**Mont-Joli Airport, Quebec
Former Building H-3, Former Coal Depot and Former Landfill**

Remediation Plan

**Responses to the Supplemental Information Request from MDDEP
dated July 20, 2011,
Concerning Remediation of the Former Hangar H-3 Sector**

Dessin / Drawing:
FIGURE 2.3
Plan d'ensemble des secteurs à réhabiliter

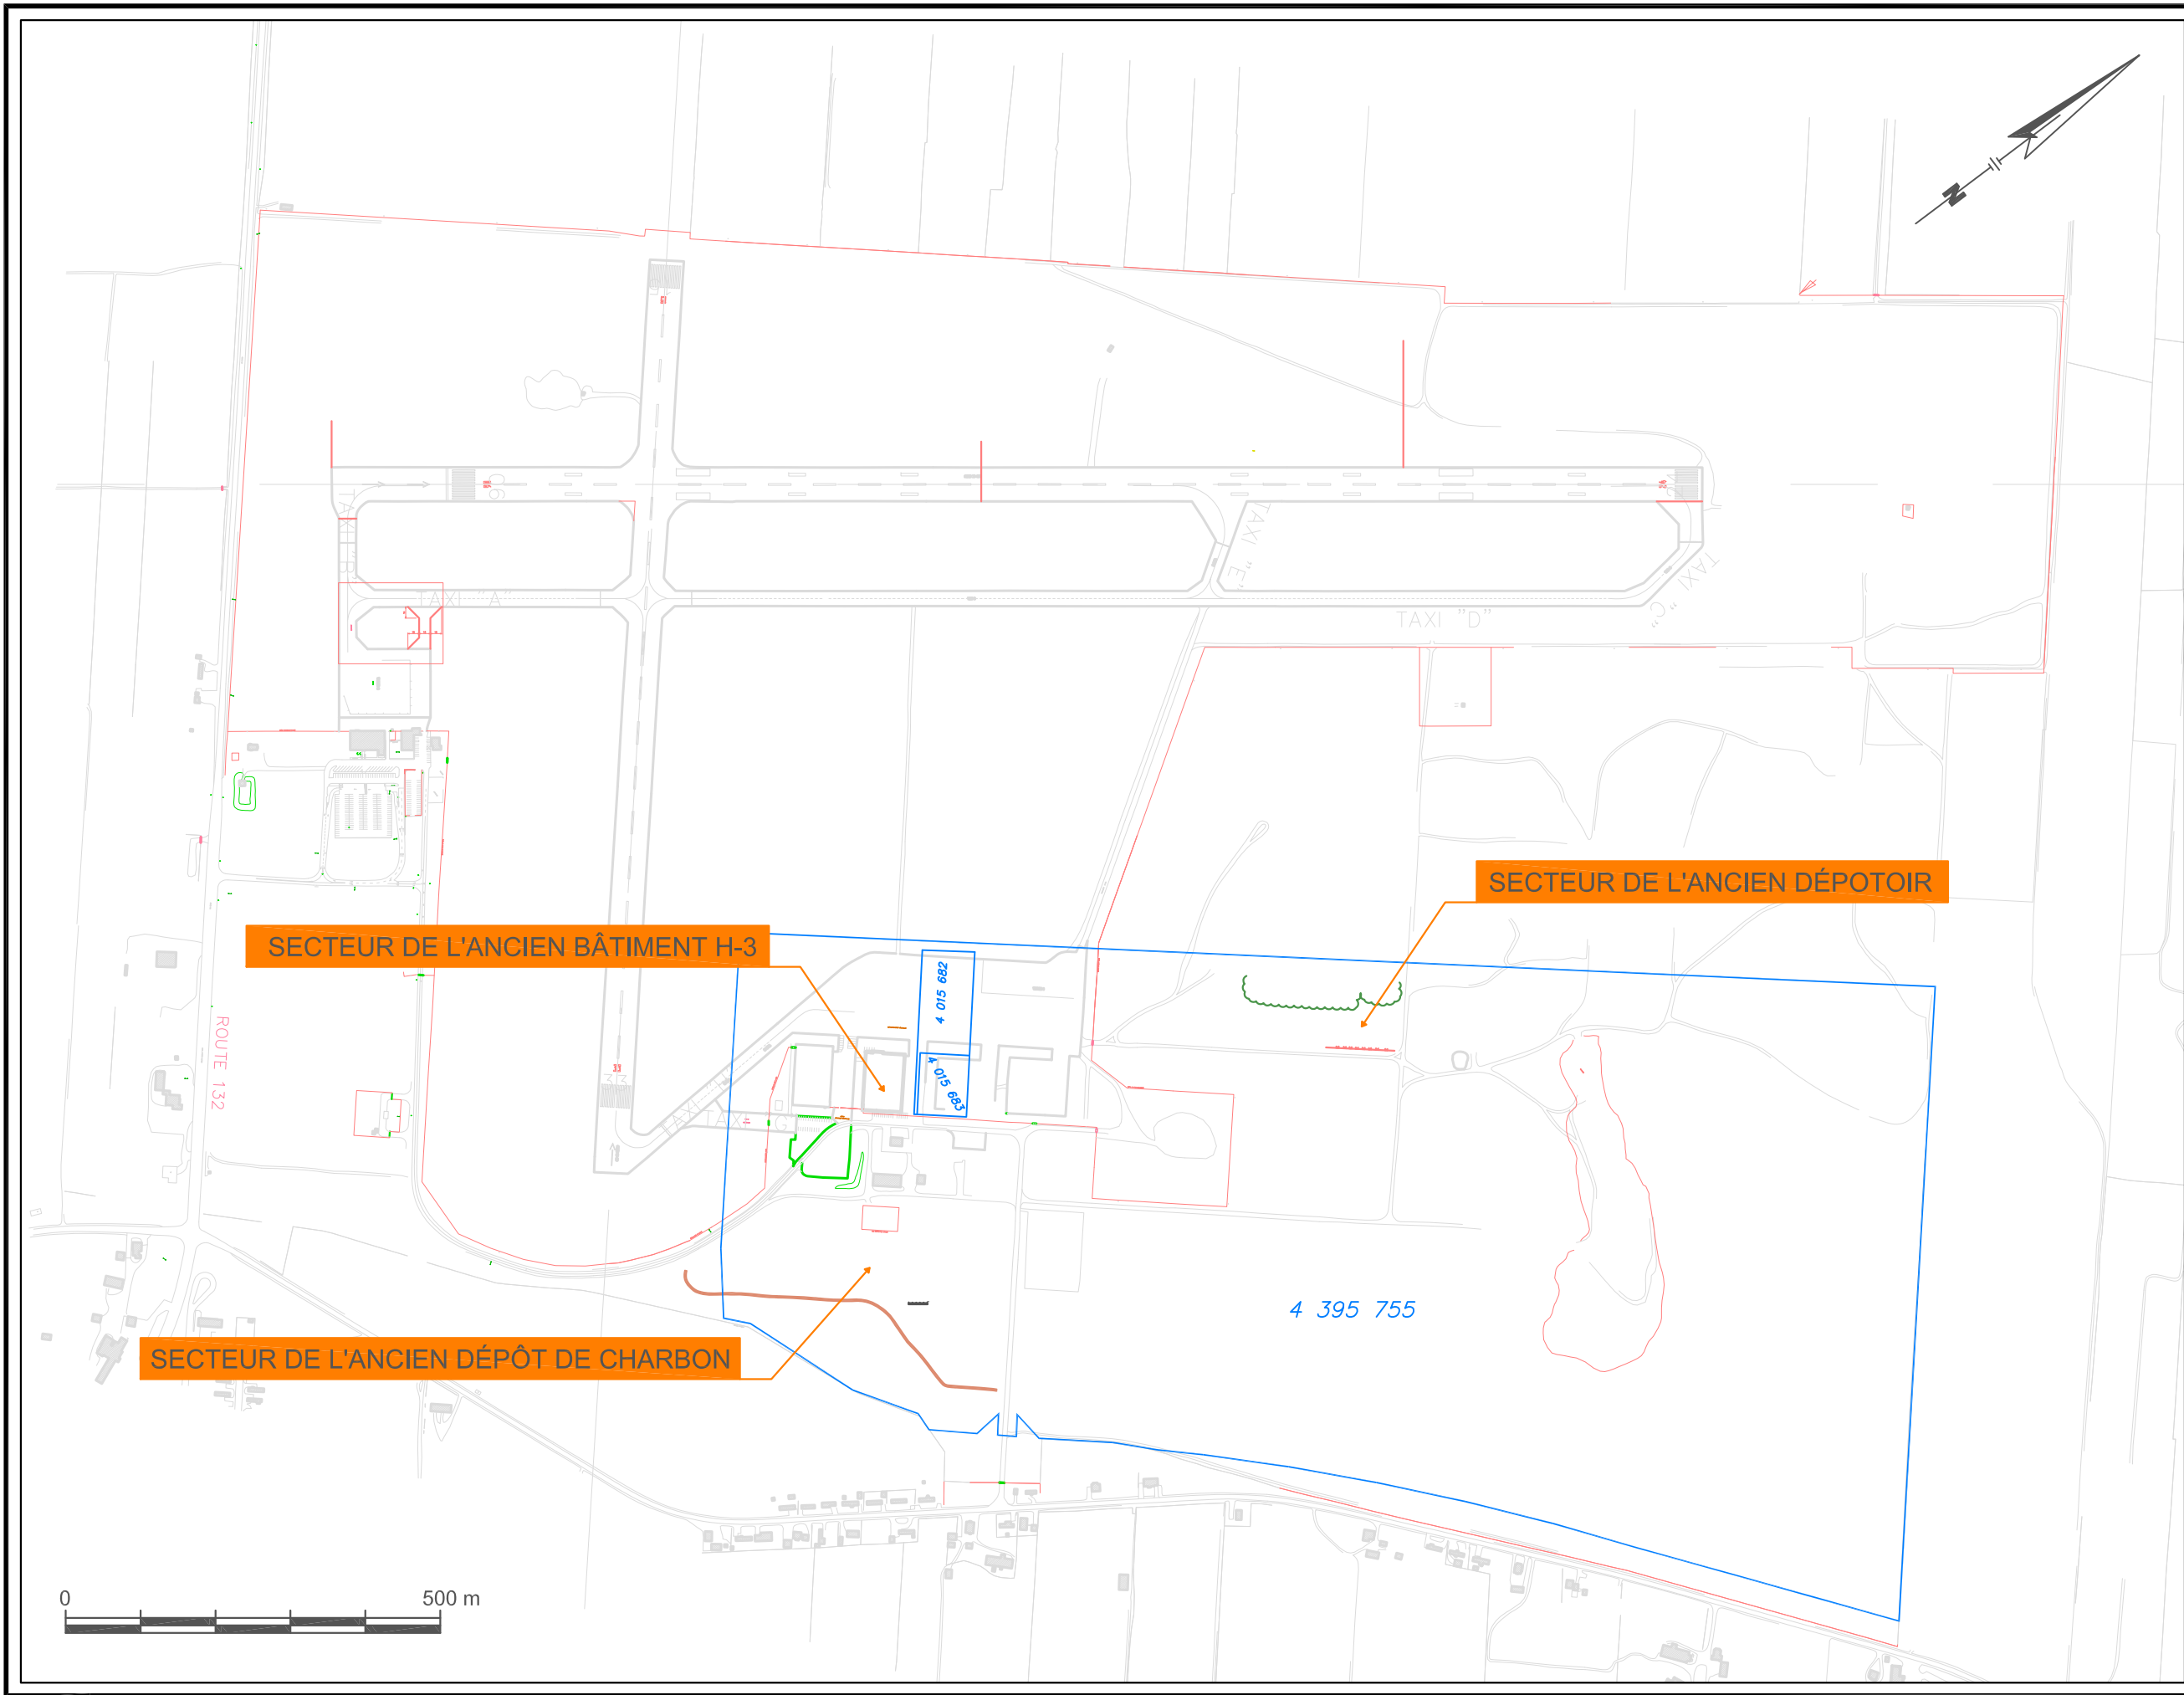
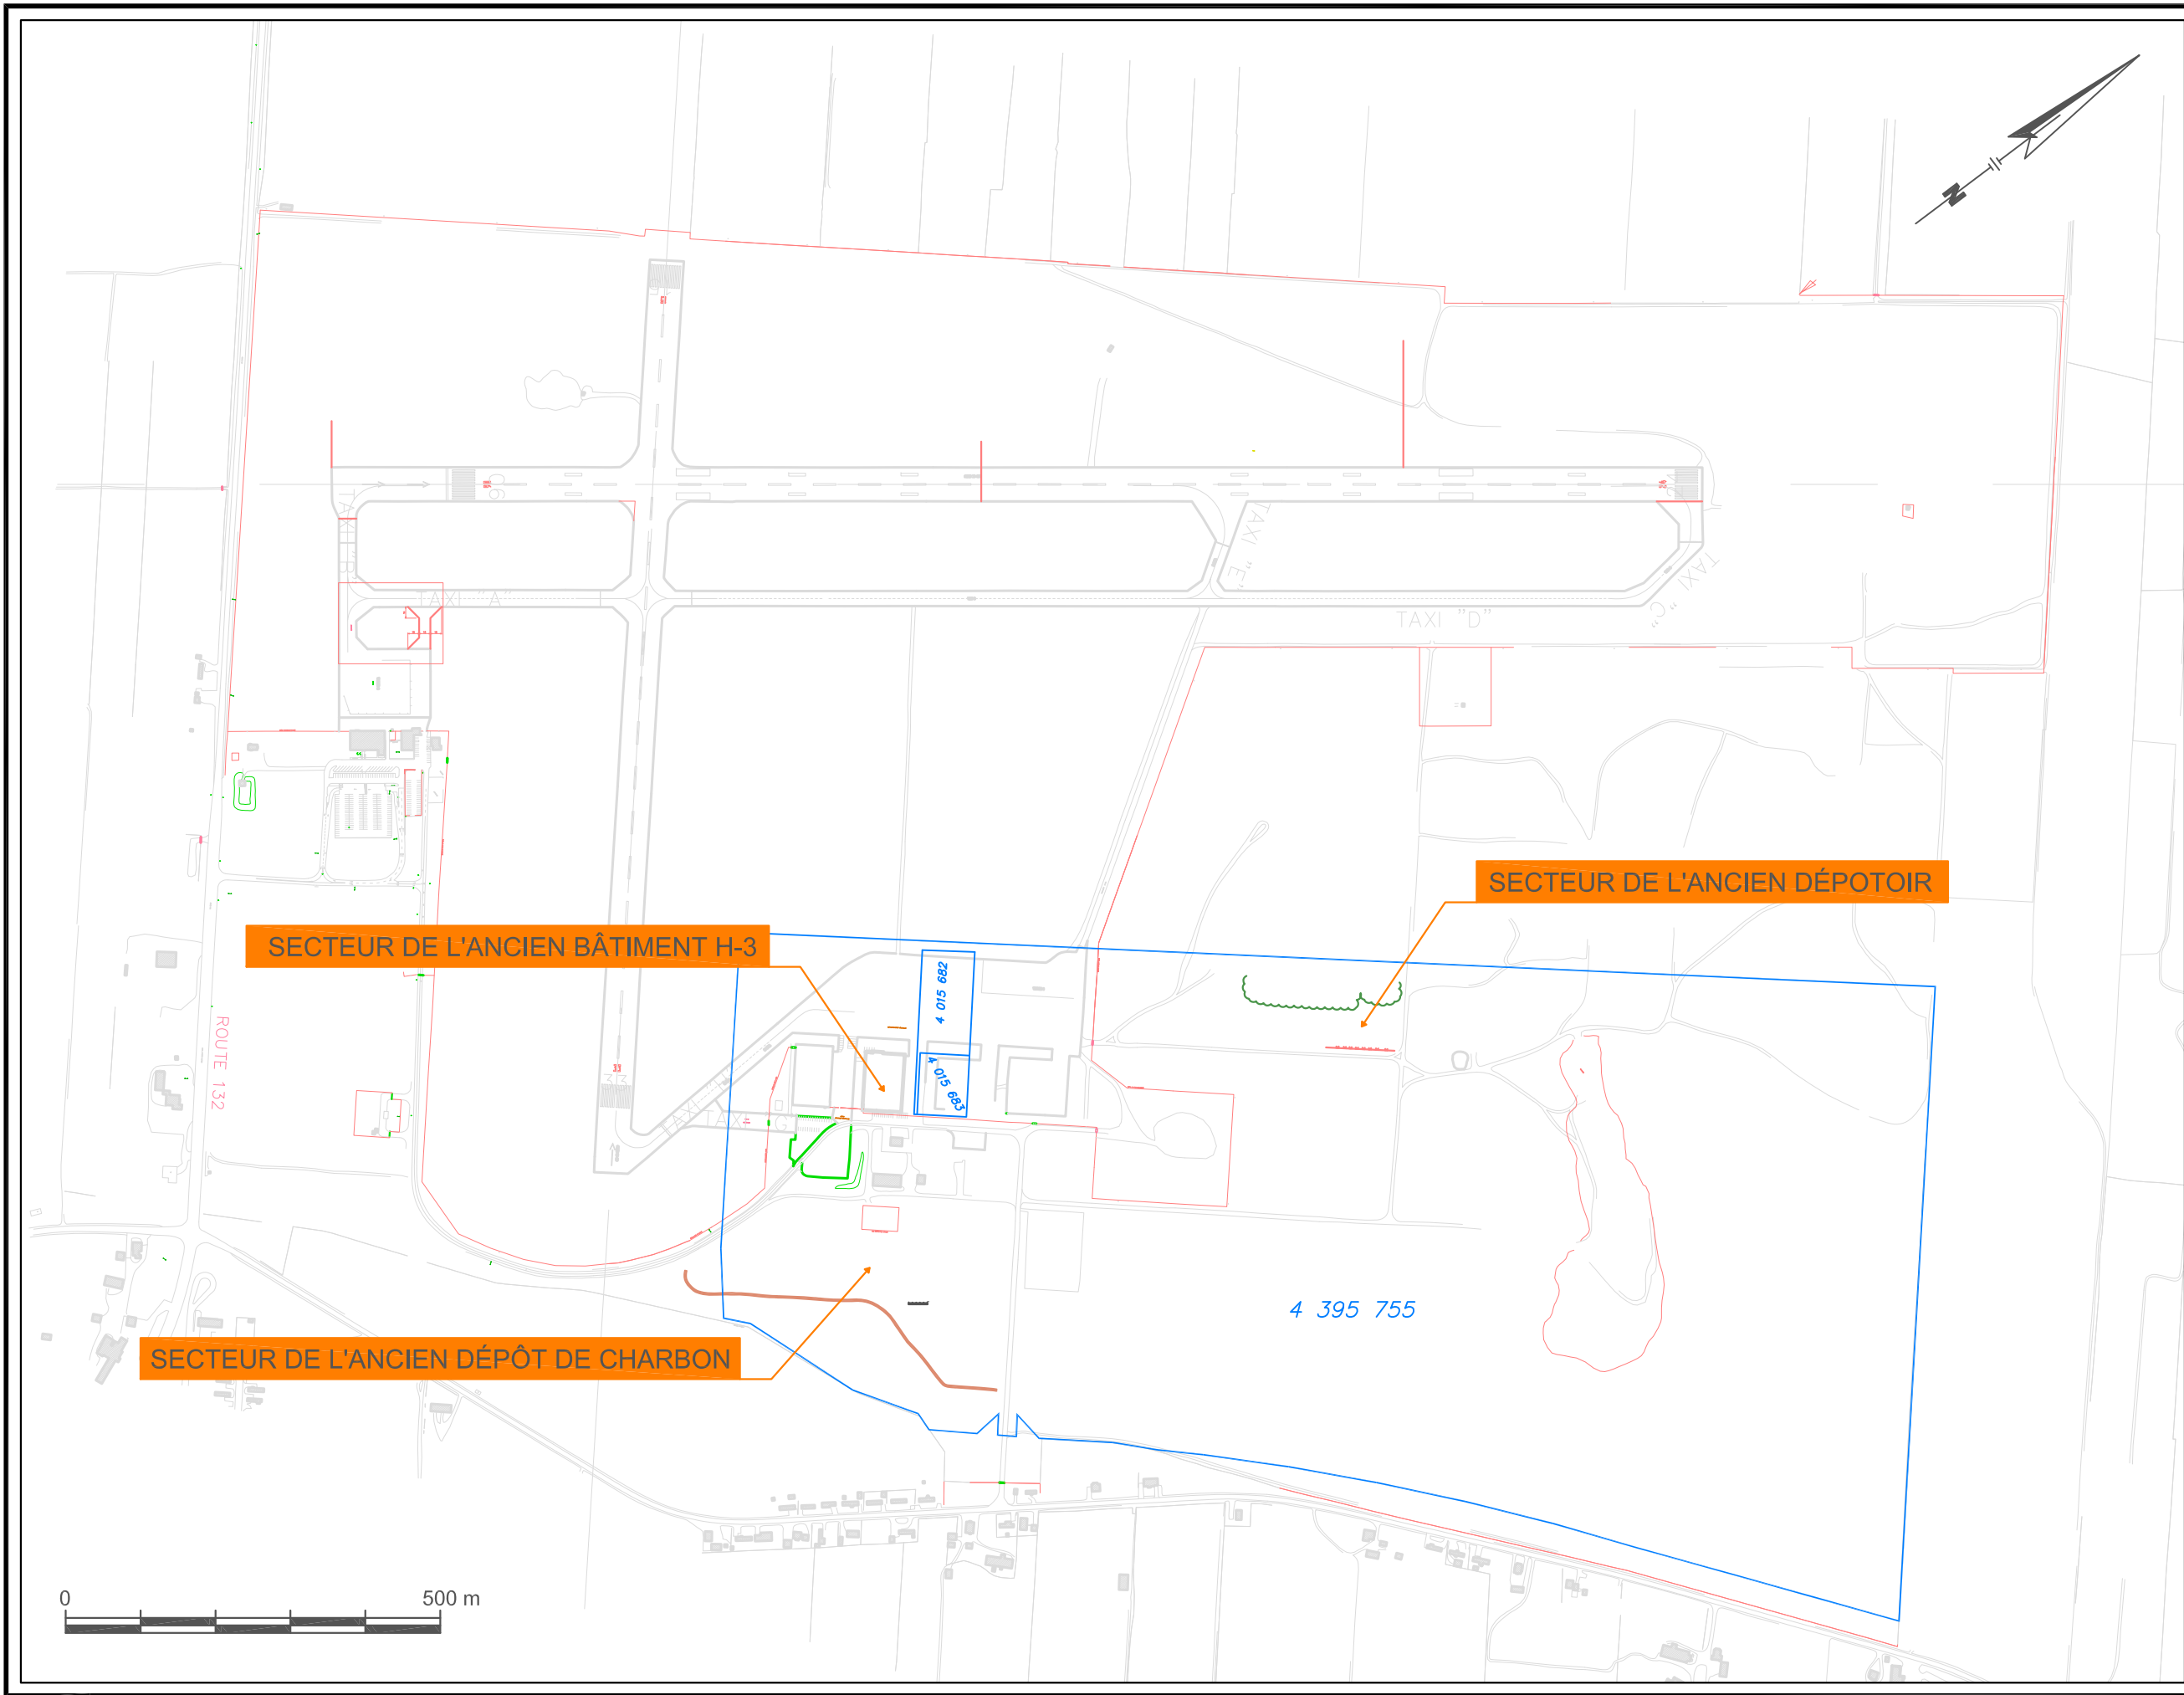
- Telephone: 418-775-7285;
 - Fax: 418-775-6320;
 - Email: mont-joli@ville.mont-joli.qc.ca
2. The site is located on part of lot 4 395 755 of the Land Register of Quebec. The boundaries of this lot are illustrated in Figure 2.3 of the Plan (see Annex 2).
